**SCHEDULED MEETING OF COUNCIL - 16 DECEMBER 2020  
ATTACHMENTS**

<b>8.1 6 LOT RESIDENTIAL SUBDIVISION - 20 FALLS ROAD, MARYSVILLE.....</b>	<b>2</b>
8.1.1 20 Falls Road MARYSVILLE 3779 - Attachments.....	2
<b>11.3 PATHWAY RENEWAL PROGRAM 2020 - 2021.....</b>	<b>38</b>
11.3.1 Pathway Renewal Program 2020 2021 - Locations.....	38

**RE: Town Planning Application Reference Number 2018/299  
Crown Allotment 13, Section H, Township of Marysville, Parish of Steavenson,  
Title Plan 569330Q, 20 Falls Road, Marysville  
Proposed 6 Lot Residential Subdivision (including a designated building envelop for the  
construction of a dwelling and associated outbuildings on each lot)  
Response to Request for Further Information 5-12-2019**

DRAWN: 15/8/18, GP  
 AMENDED: 24/09/20, GP  
 VERSION: 19  
 SHEET: 1 OF 1  
 PLAN No.: KIRIII25PP.dwg

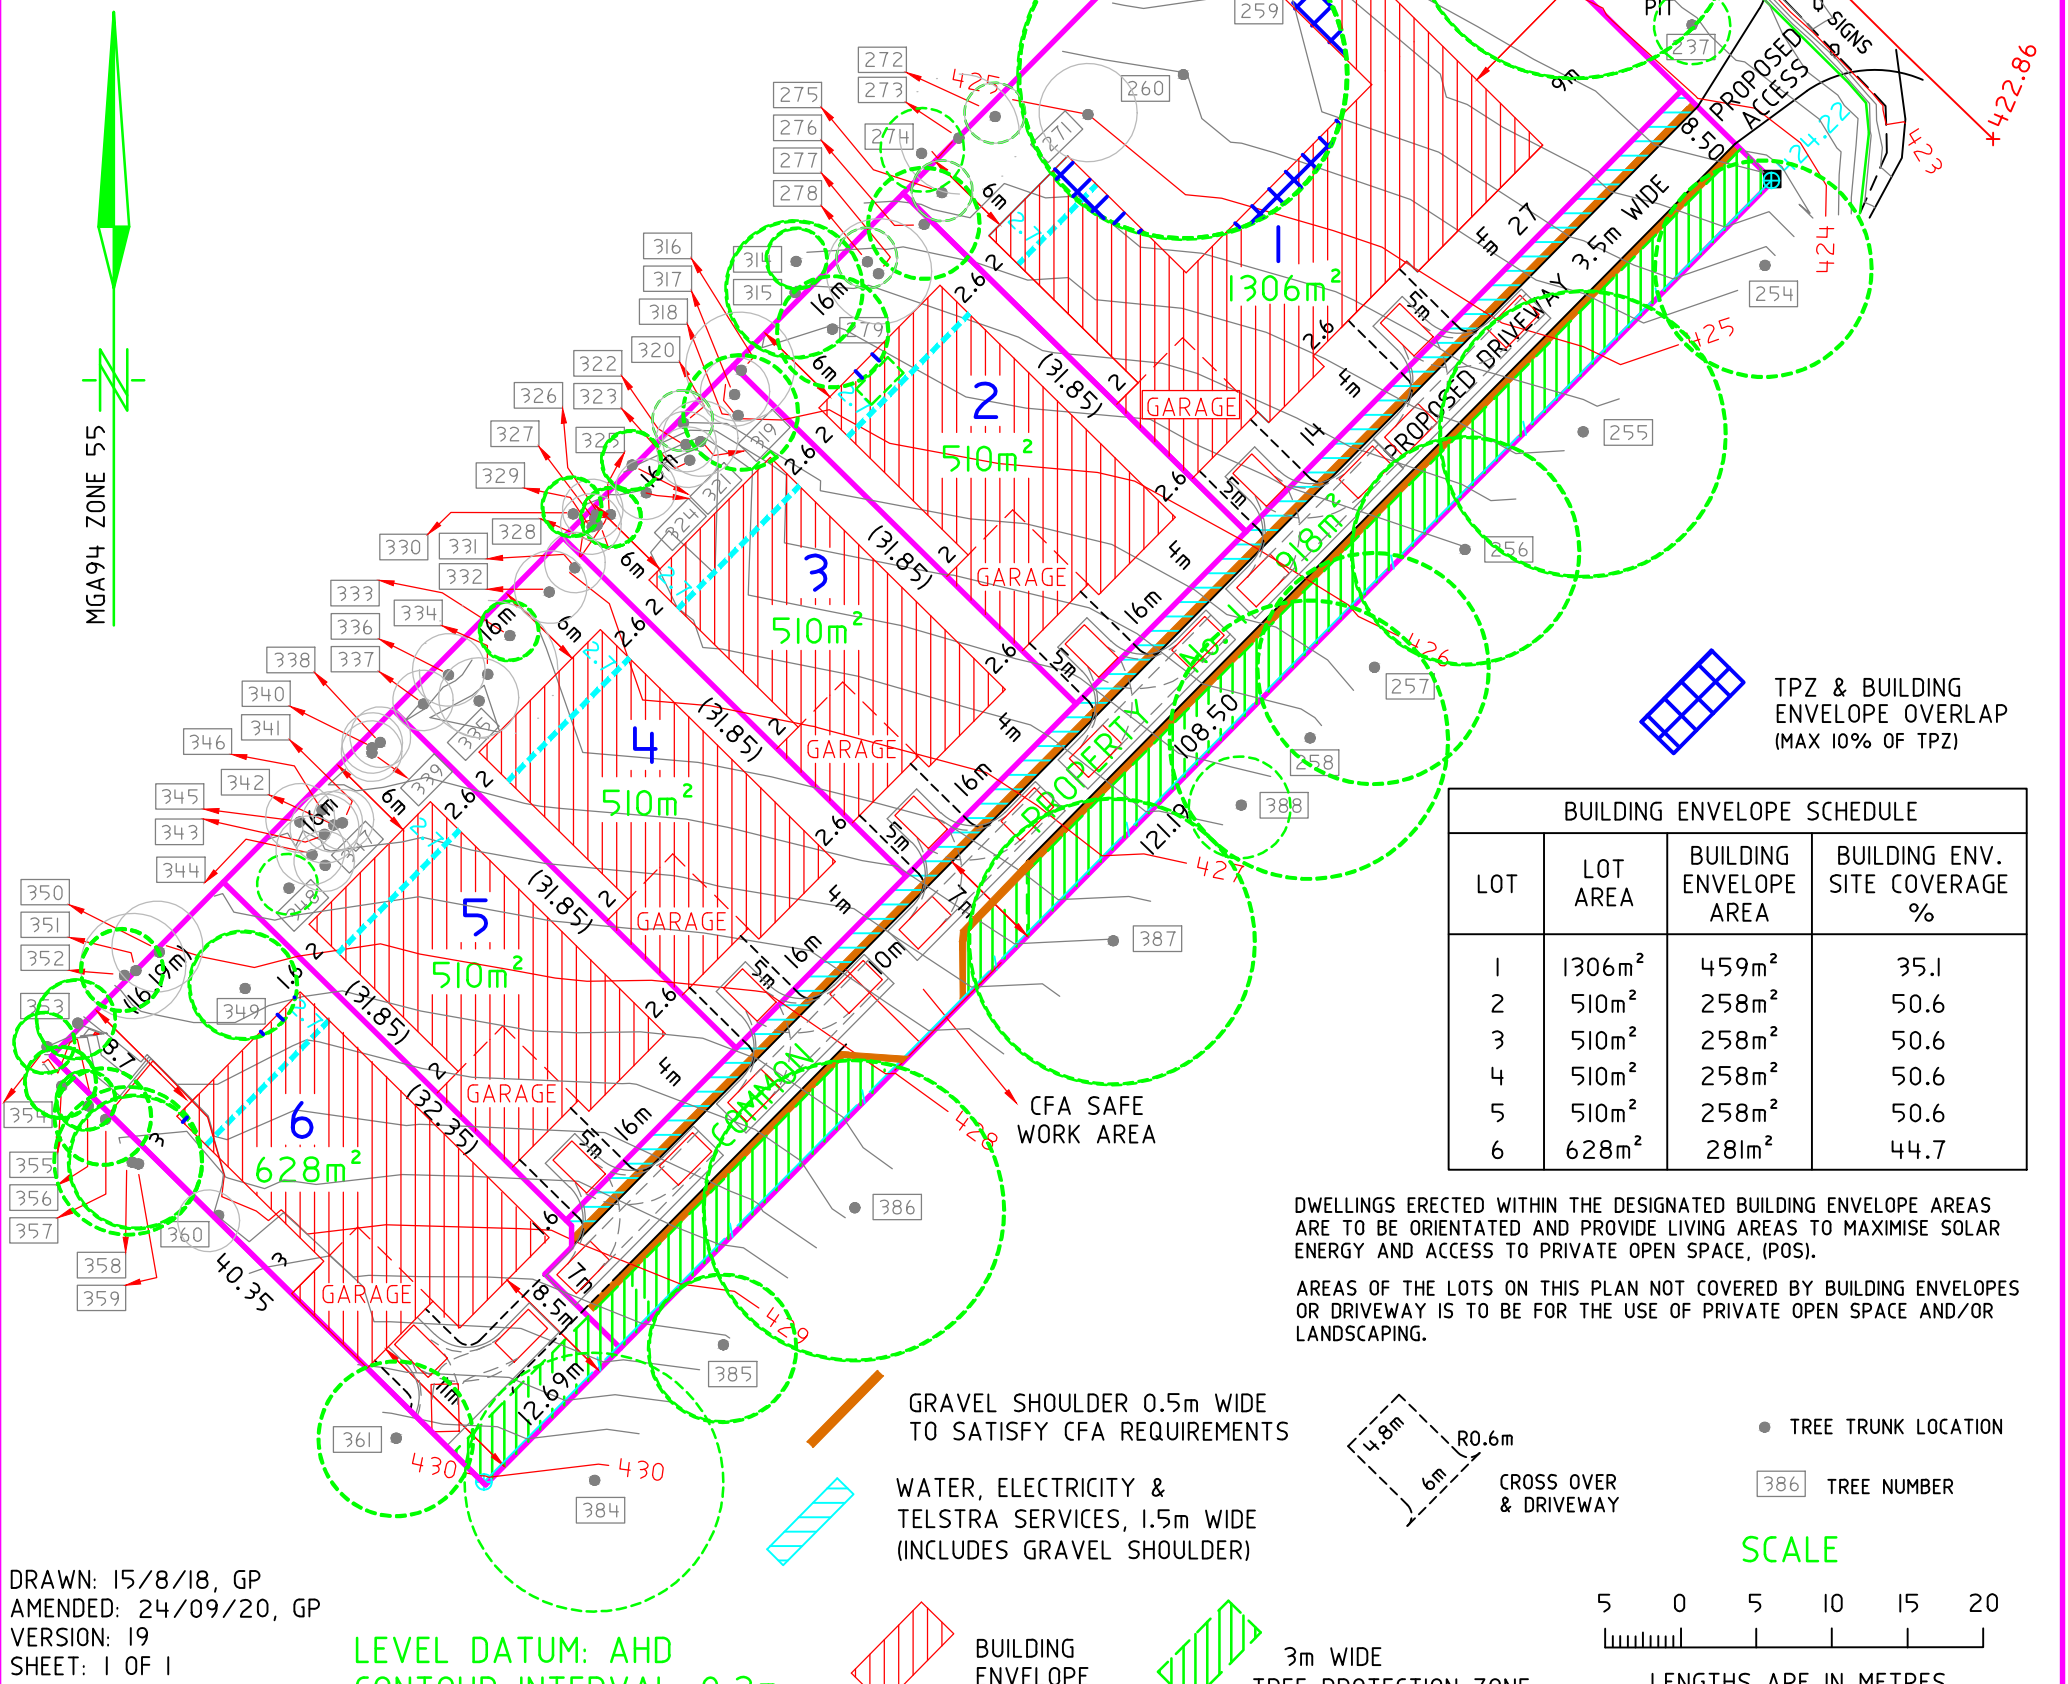
2. An updated site plan including the information listed above but with correct TPZ's for trees 259 and 260. These trees TPZ's have been incorrectly shown and they are significantly larger and this may impact on the ability of Lot 1 to contain an appropriate building envelope.

3. Further explanation from the project arborist in relation to the works required to provide the drainage points to the 7 lots along the north eastern boundary and the manner in which the trees will be protected. It is considered that the boring and trenching will likely impact on the trees to the point that their useful life expectancy will be significantly reduced. Details need to be provided in relation to what would happen in the event of major roots being encountered and what alternative solution may be achieved. All other options need to be considered as the loss of vegetation along this boundary is not supported and a further reduction in the number of lots would provide more space for services to be provided in a manner which will have less impact on the trees to be retained.

Refer attached amended Plan of Subdivision prepared by Salter Surveying Pty Ltd. It should be noted that tree 259 is now recommended for removal in order to comply with the 5m canopy separation requirement of the Bushfire Management Plan.

The originally proposed sewer main along and within the north-western boundary has been relocated to the front of the lots to avoid any potential construction impacts with the retained vegetation along that north-western boundary. The sewer main will fall towards lot 1, either immediately adjacent to other services proposed within the front setback of lots 1-5 or in a common trench (tbc), to a contour point where the main will then be directed in a north-westerly direction towards the north-west boundary, then flow into the existing sewer pit in Falls Road as a gravity fed sewer main. The Arborist has confirmed that there is sufficient space between the building envelop for Lot 1 and the TRPZ of tree 236 that there will be no damage to tree 236 as a consequence of the construction and laying of the sewer main in this vicinity.

In addition to the above changes, the 'CFA Work Safe Area' has been moved marginally to the south-west to avoid any potential impact of the TRPZ's of nearby trees located on the adjoining property.

The proposed accessway will also be constructed of permeable material as recommended by the Project Arborist to the satisfaction of the Responsible Authority

**Figure 6 Proposed sign location**

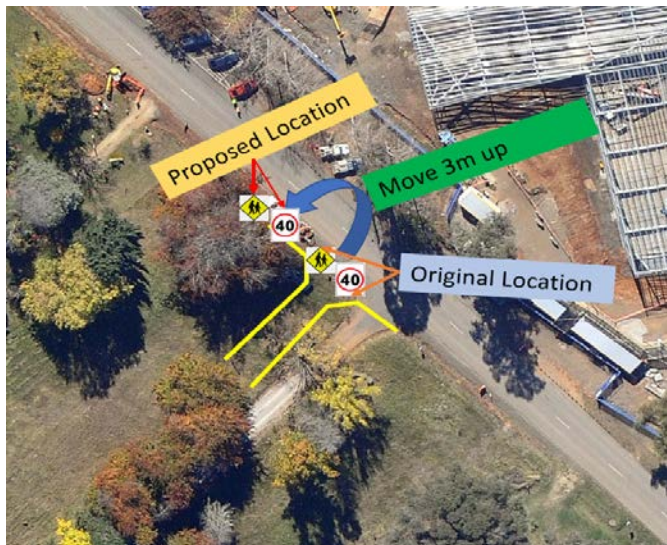
<p>An audit of the existing traffic signs and any impacts from the proposal, with due consideration to expected traffic movements to and from the site</p>	 <p><b>Figure 4 Watch out for pedestrian sign (taken during site visit)</b></p>

These signs are located within the proposed site accessway. As such, the signs will have to be relocated 3m northwest of their existing position. Refer **Figure 6** below:
